**DEFENSE NUCLEAR FACILITIES  
SAFETY BOARD**

## Staff Report

November 27, 2018

### Device Assembly Facility Seismic Hazard

**Figure 1** – Comparison of horizontal and vertical response spectra derived from [3] and [4].

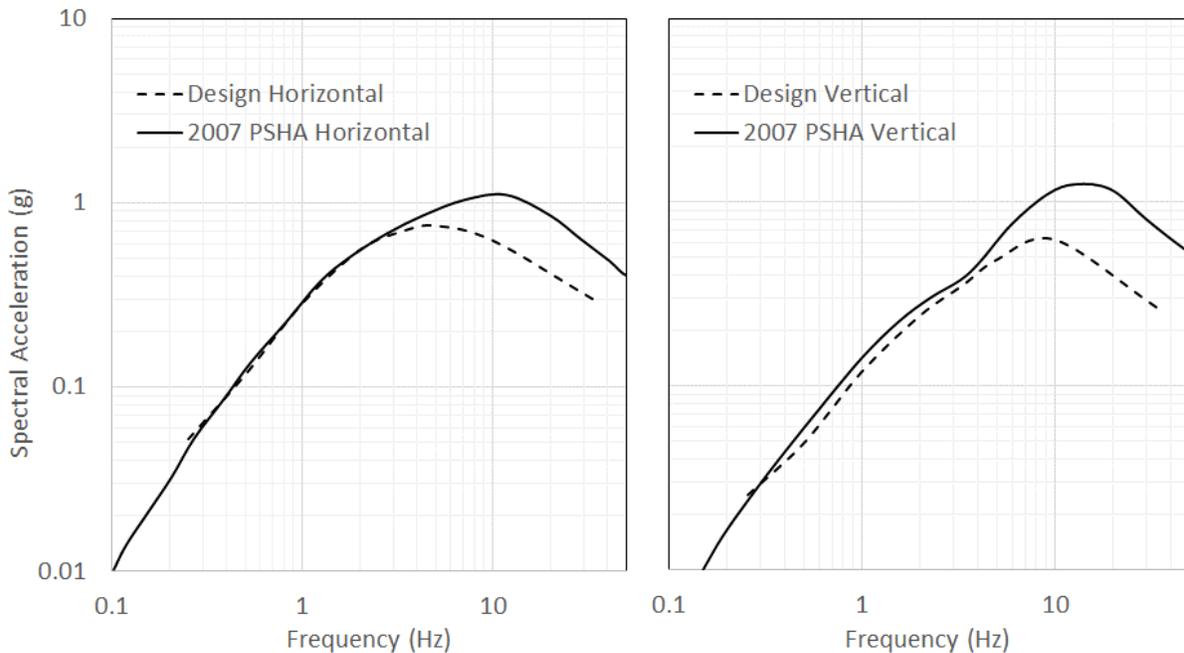
**Background.** As part of the 10-year assessment of the seismic hazard, the previous site contractor, National Security Technologies, LLC (NSTec), analyzed the seismic hazard for DAF in 2007 using a probabilistic seismic hazard analysis (PSHA) approach. In the 2007 PSHA [3], the ground motion response spectra significantly exceeded the previous 1995 analysis [4] for the design-basis earthquake response spectra in a sensitive frequency range for safety-related structures, systems, and components (SSCs). Safety-related SSCs are generally sensitive to ground motion between 1 and 10 Hz. The horizontal ground motion spectrum in the 2007 PSHA exceeds the horizontal seismic design spectrum at 3 Hz and above. The vertical spectrum in the 2007 PSHA also exceeds the corresponding design spectrum for the same frequency range. A comparison between the 2007 PSHA and design basis response spectra is provided in Figure 1.
